Transient section 145.3.8.6 v110

145.3.8.6 PD behavior during transients at the PSE PI

Figure 145-31—Transient test conditions operating bounds

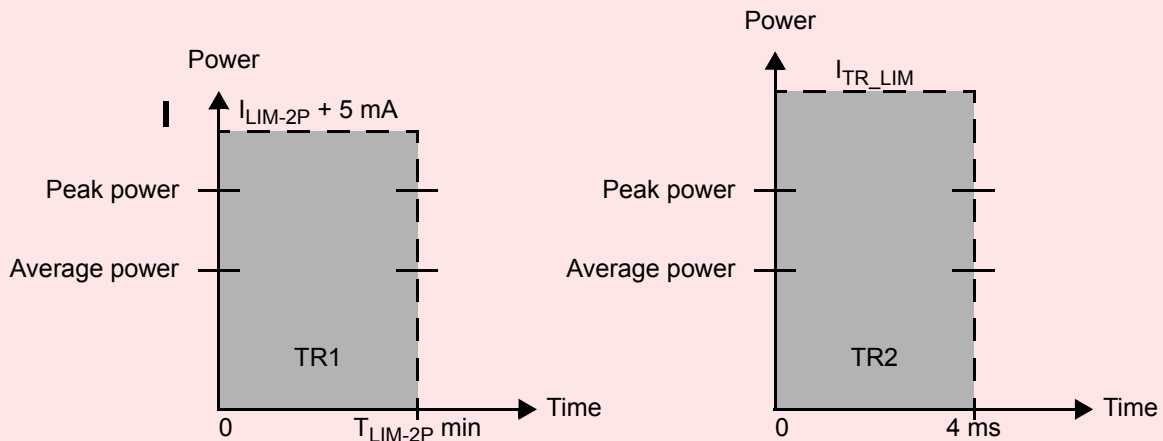
- Figure 145–31 tries to show an overview of the PD requirements when exposed to transients TR1 and TR2. Issues:
- The Figure and description of parameters used is a complete duplicate of normative information in the same subclause
 - It doesn't add any new information or insight
 - The Figure y axis is labeled “power” but at the top of the box a current level is denoted
 - T_{LIM-2P} (PSE parameter) is tied to PSE Type. It is 10 ms for Type 3 and 6 ms for Type 4. The PD does not see the difference between a Type 3 and a Type 4 PSE, hence the reference to T_{LIM-2P} needs to be replaced by “6 ms”.

Table 145–29 defines two PSE transient conditions and PD Types to which these apply. ~~Figure 145–31 shows operating bounds for the transients in Table 145–29. The shaded regions begin with the application of the transient and end at the times indicated in the Figure. These shaded regions can exceed normal operating limits and are not included in the average and peak operating power requirements set forth in Table 145–28. During a transient the input power of the PD may exceed P_{Peak_PD} .~~

The proposed resolution is to remove the Figure and description and correct the text accordingly.
